Montgomery Park Report: Citizen Feedback on Revised Draft Plan

**Department of Recreation, Parks & Cultural Activities
and
Park and Recreation Commission
Alexandria, Virginia**

Darrel W. Drury, Ph.D.

November 12, 2015

FIGURE 1 - % LOVE / DON'T LIKE RECOMMENDATIONS

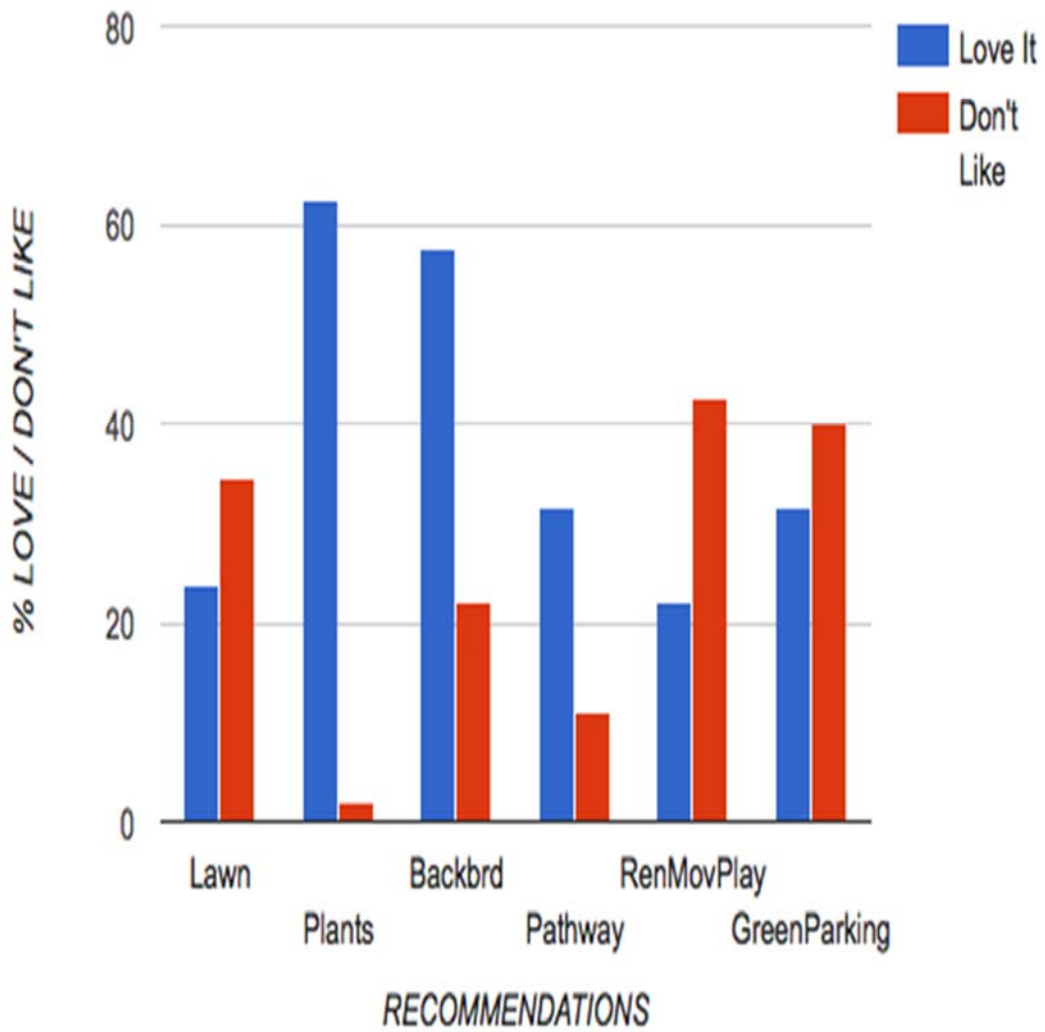
The data presented in Figure 1 provide clear evidence that a substantially larger proportion of park users “don’t like” the recommendation to create an expanded, passive lawn as compared with those who “love” the idea. Whereas only 23.6% of respondents favor the idea, 34.6% reject it outright.

According to Figure 1, it would seem that there is little support for the recommendation to renovate the playground and relocate it closer to Royal Street. In the 2015 survey, respondents were asked what they thought about renovating and moving the playground. While 22.2% stated that they “love” the idea, nearly twice as many (42.6%) indicated that they “don't like it.” But responses to this question must be interpreted cautiously, as it represents a classic example of a common error in survey design—the “double-barreled” question. By combining two distinct issues—in this case, renovation of the playground and relocation of the playground—into a single question, it becomes nearly impossible to interpret the meaning of responses. Do respondents object to renovating the playground or to moving it?

No recommendation garners more support and less disapproval among Park users than that concerning the improvement of plantings along Royal Street—62.5% “love it” and only 1.8% “don’t like it” (see Figure 1). Moreover, it is clear from the open-ended comments of those responding to the 2015 survey that users would like to see *beautification* assume a more central role in the redevelopment of the *entire* Park, not just the area bordering Royal Street (see Exhibit 4). Respondents voice consistent support for such features as: landscaping to hide “the ugly metal fences” that surround the playground and dog park; more shrubs around the perimeter of the Park; and a fountain (separate from the water feature already proposed for the playground) in what is now open space, surrounded by flowering plants and trees.
